**BID BULLETIN NO. 02**

ITB No.: **bac-23-0804a**

Project Name: **Supply, Delivery and Installation of Regulatory Signages - TPMO**

**ANNEX "A"**

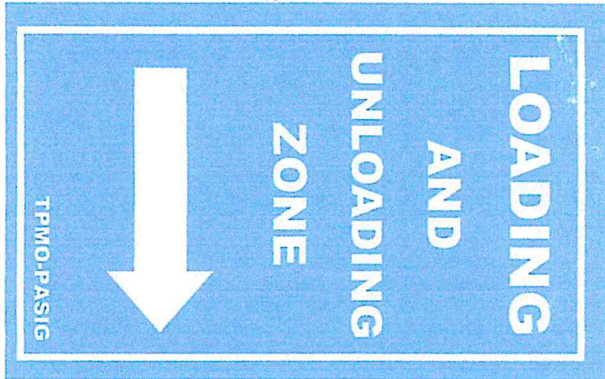
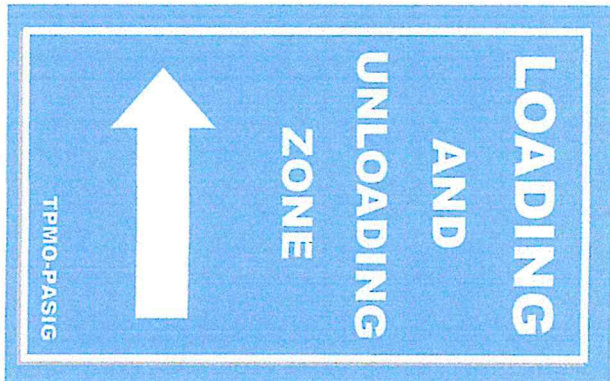
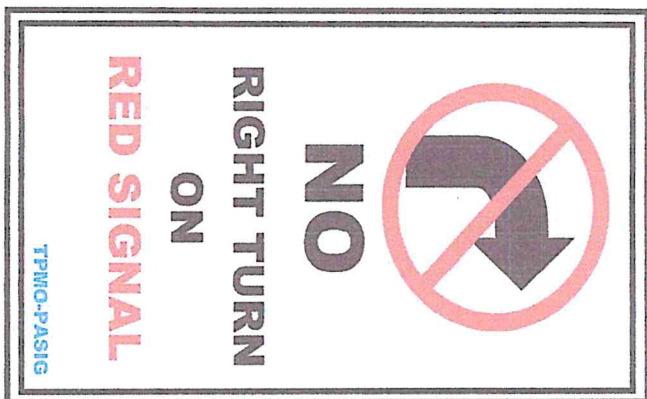
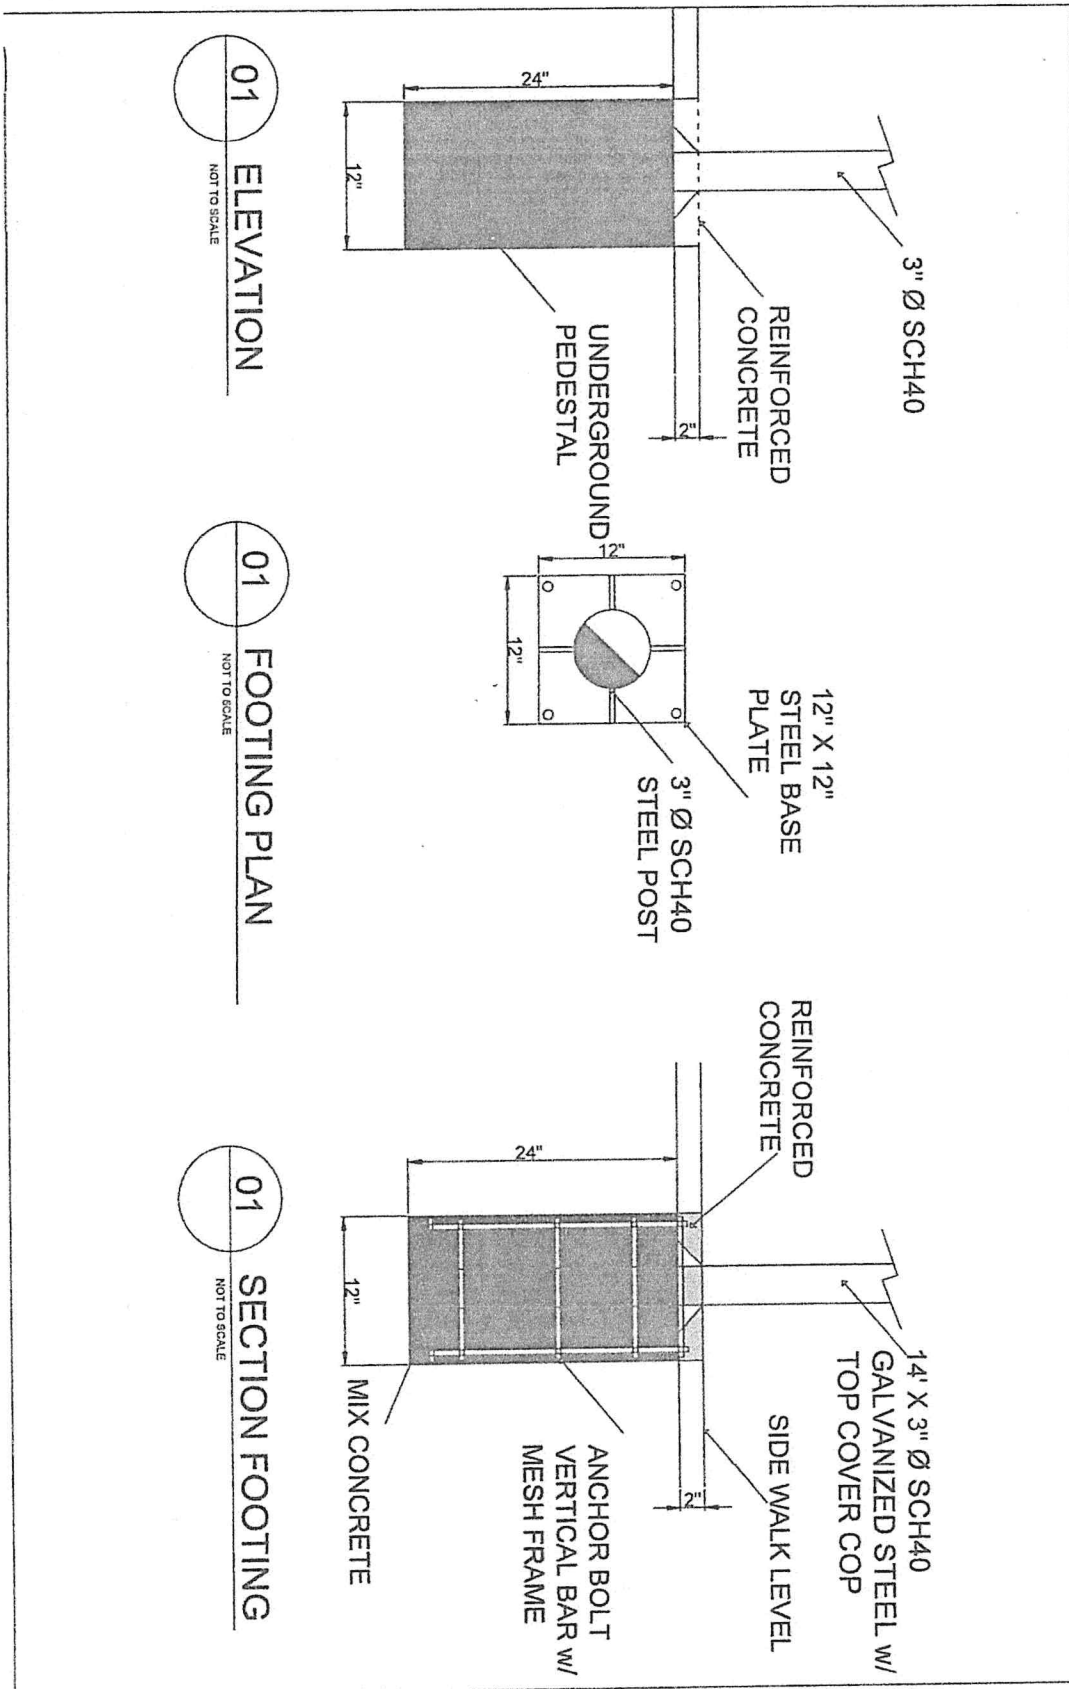
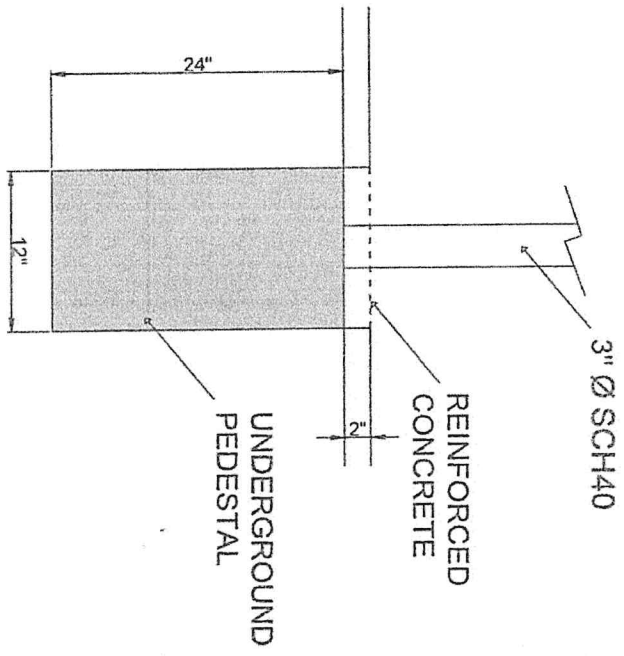
SPECIFICATION										
-12ft. pole 80mm diameter paint finish with color blue										
-G.I Sheet 2mm Thickness										
-High Intensity Sticker (Reflective)										
SPECIFICATION										
<b>-14ft. pole 80mm = 3.2" diameter</b> paint finish with color blue										
-G.I Sheet 2mm Thickness <b>With bracket/Frame in Signages</b>										
-High Intensity <b>Prismatic</b> Sticker (Reflective)										
2	<p><b>SAMPLE OF FRAME WITH BRACKET</b></p> <p>See Annex "A"</p>

02 SECTION FOOTING  
NOT TO SCALE

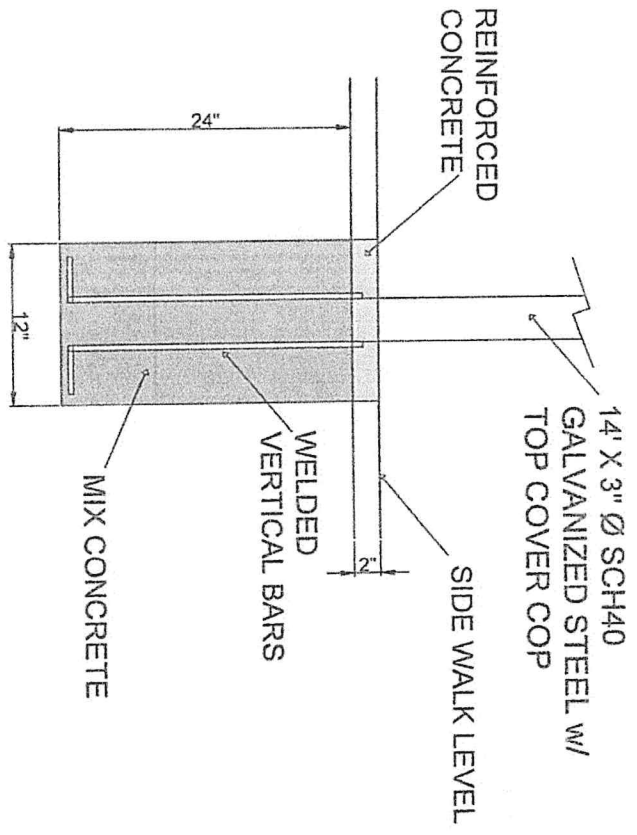
<b>3</b>	<b>BASE FOOTING MEASUREMENTS</b>  See Annex "B"
<b>4</b>	<b>SAMPLE OF POLE WITH SIGNAGE AND COLOR BLUE PAINT</b>  See Annex "C"
